Master
Development
Drainage
Plan /
Preliminary
Drainage
Report

Eagle Rising

Project No. 61145

PCD File No.: SP205

| Channel Designation | D (ft) | n |
|---------------------|--------------|-------|
| Grade Check & Bank | 0.43 Type VL | 0.034 |

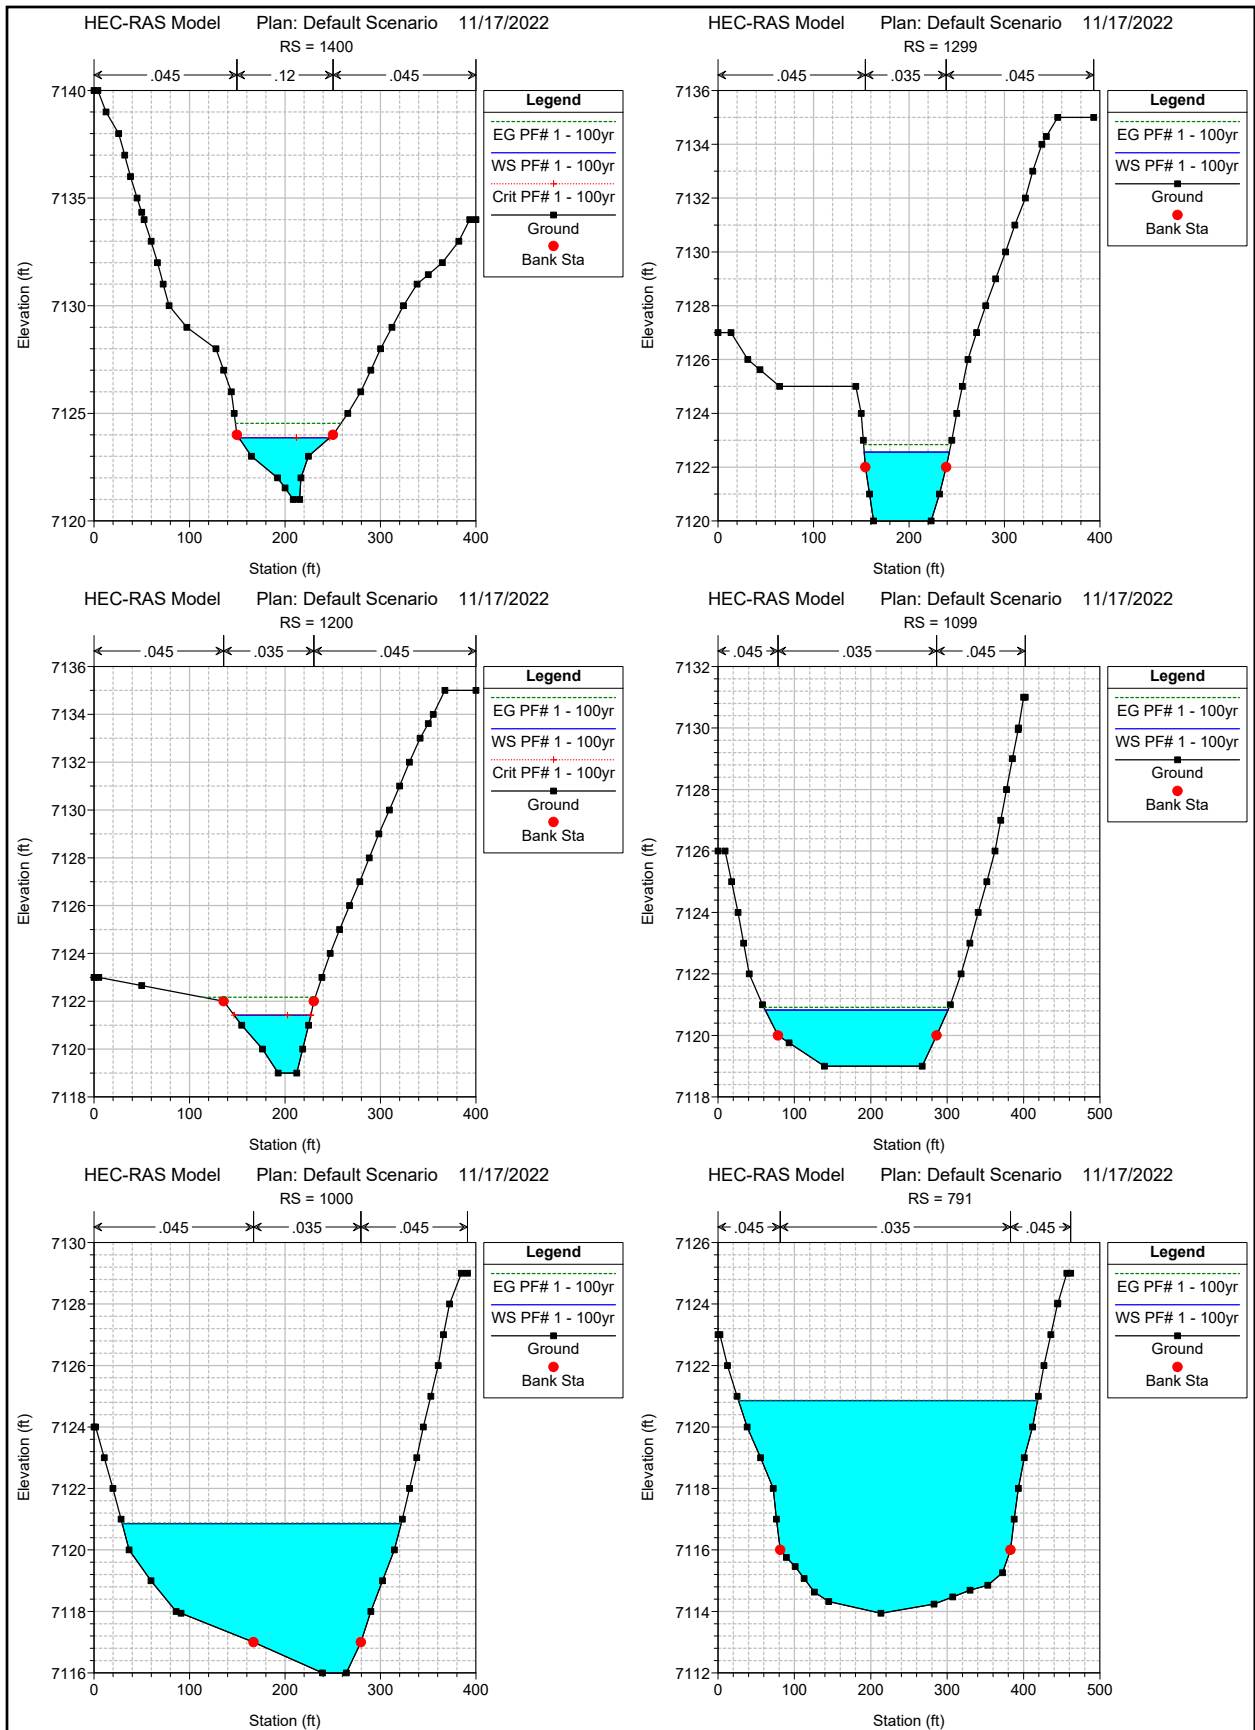
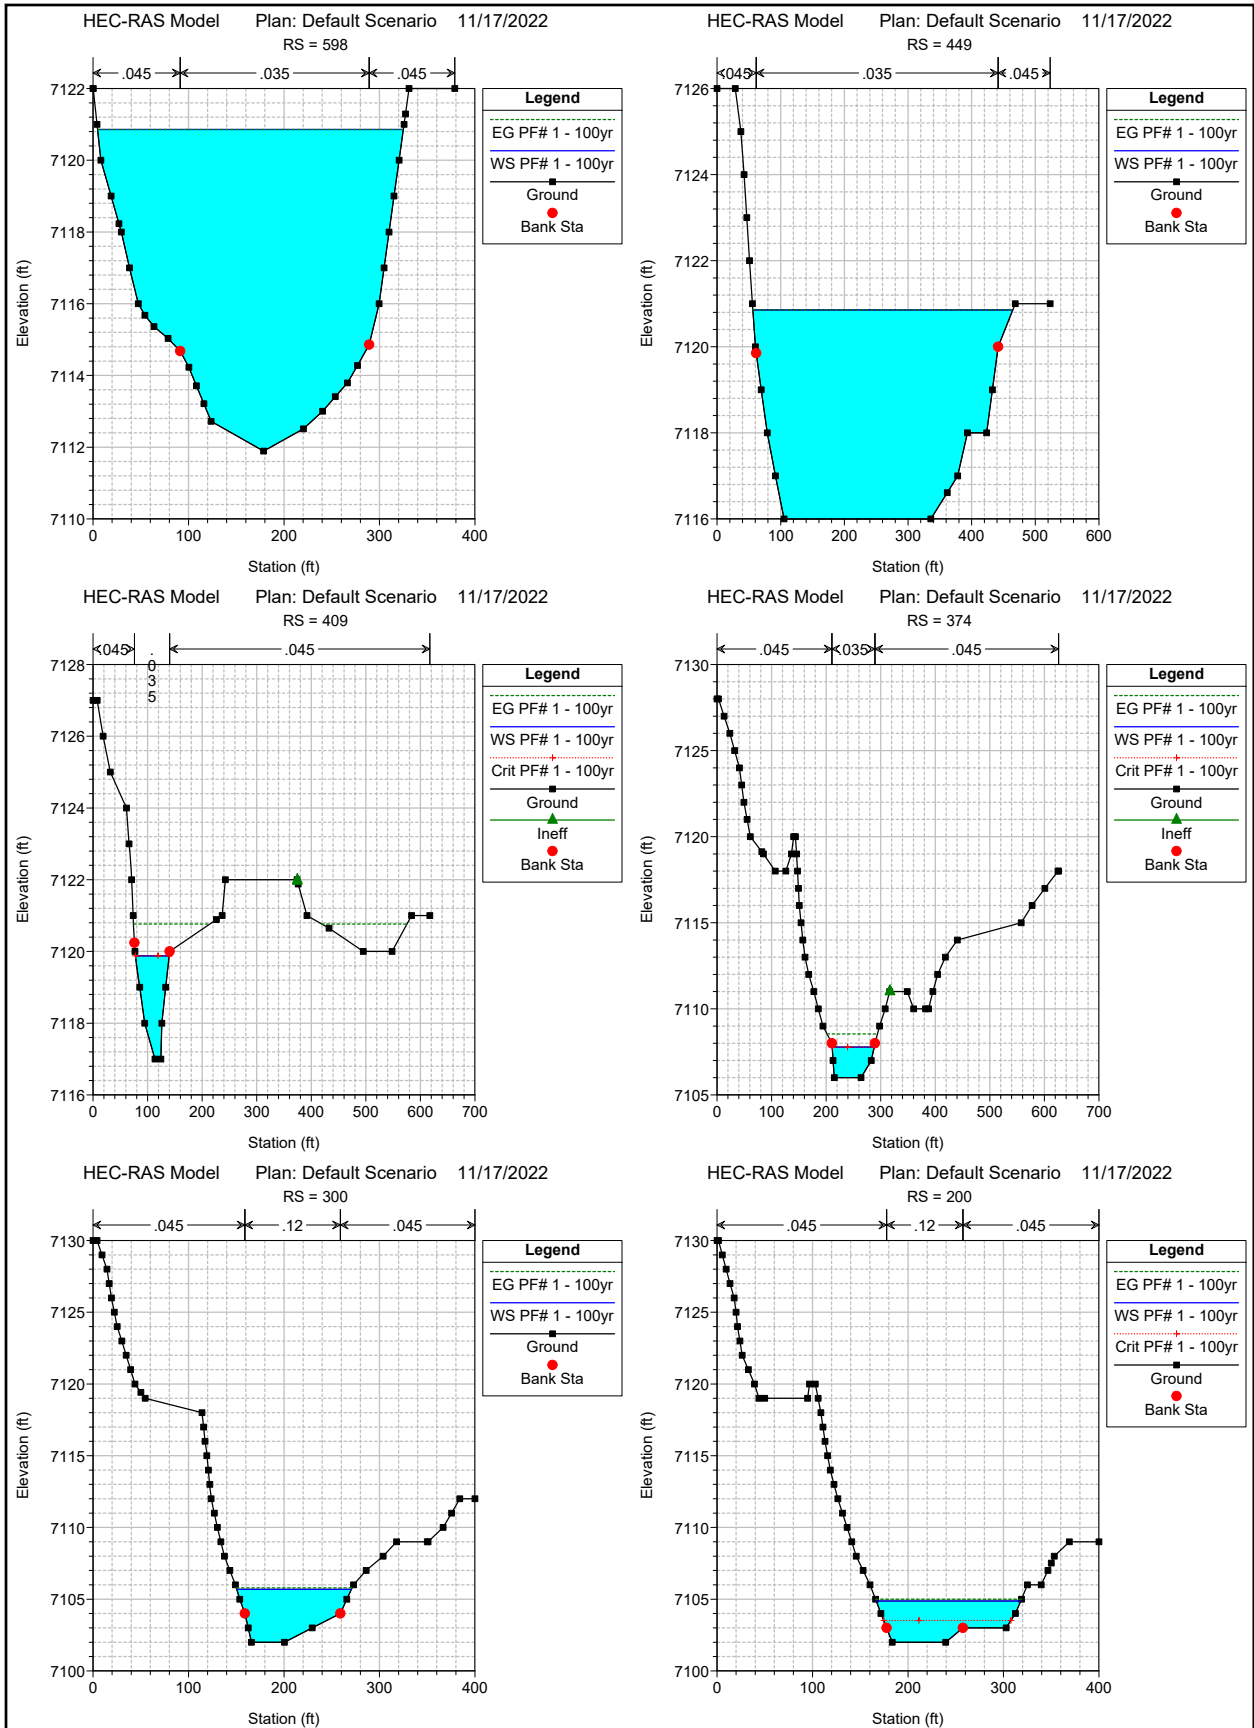
Provide plan detail

HEC-RAS Plan: Default Scenario River: Cottonwood Creek Reach: Eagle Rising Profile: PF# 1 - 100yr

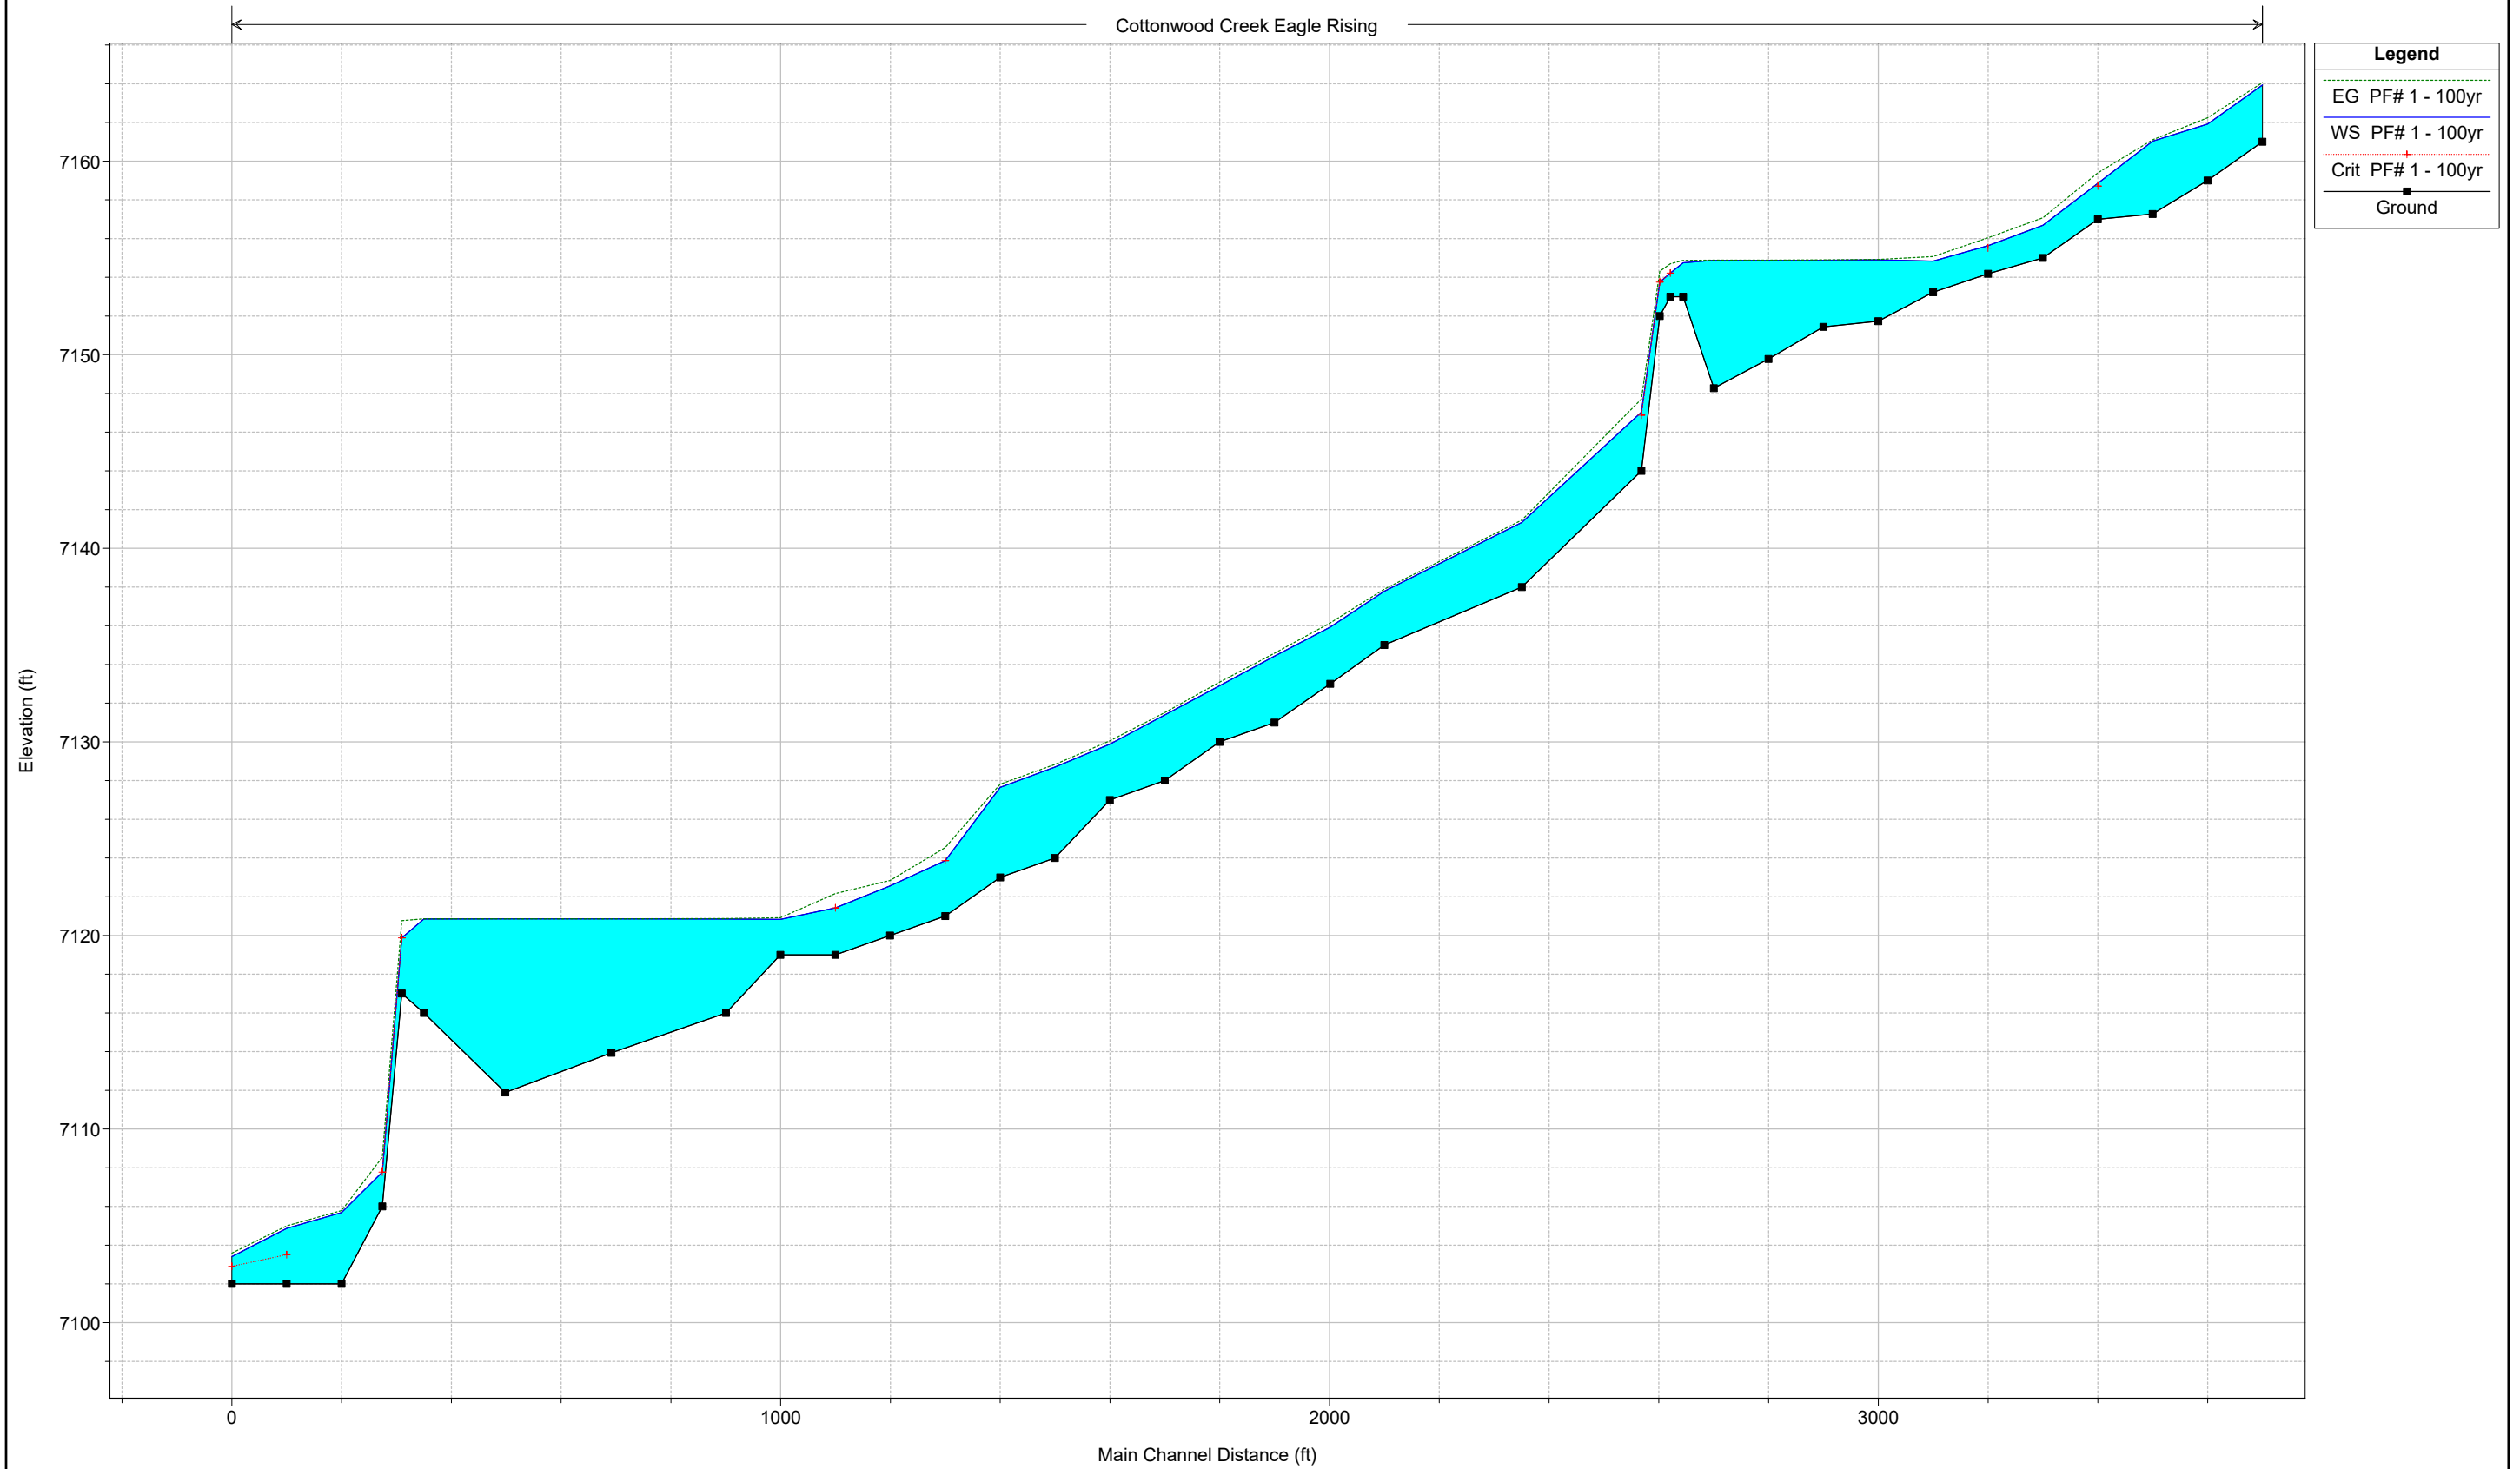
what keeps flow from going this way?

flow path following contours?

overflow path?

PRELIMINARY PLAN - REINSTATED
EAGLE RISING
 CASAS LIMITED PARTNERSHIP #4
 P.O. BOX 2076, COLORADO SPRINGS, CO 80901-2076

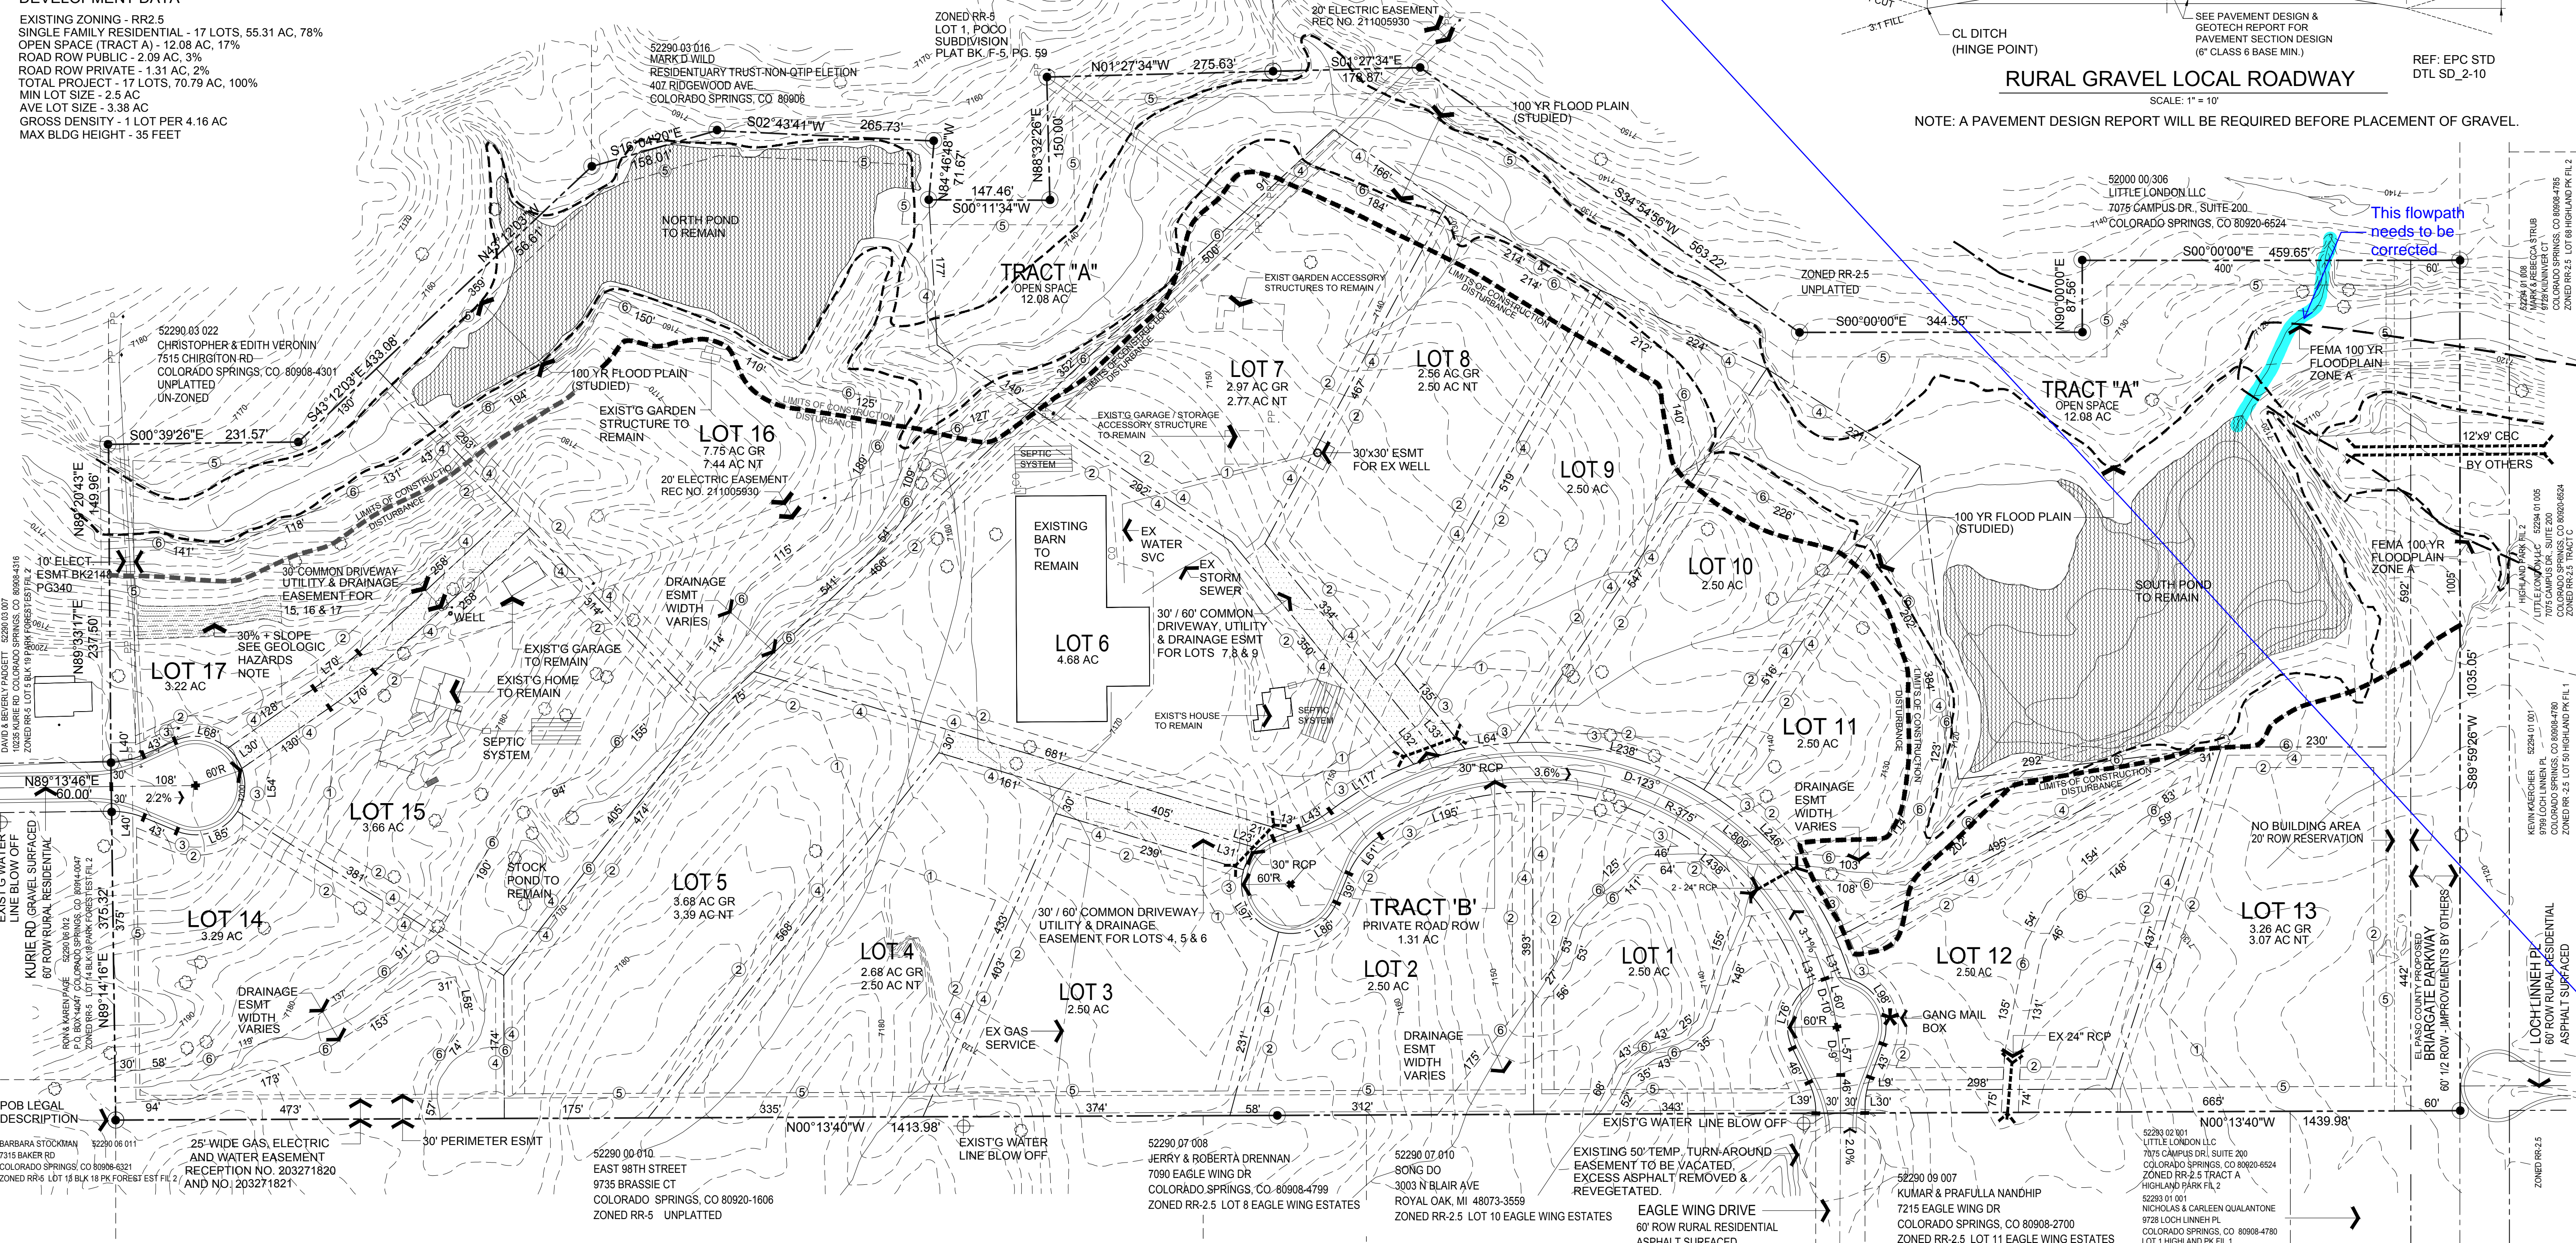
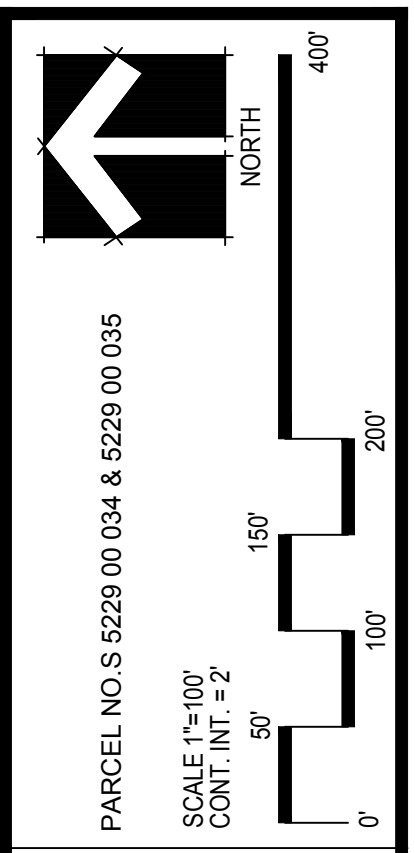
Provide latest version
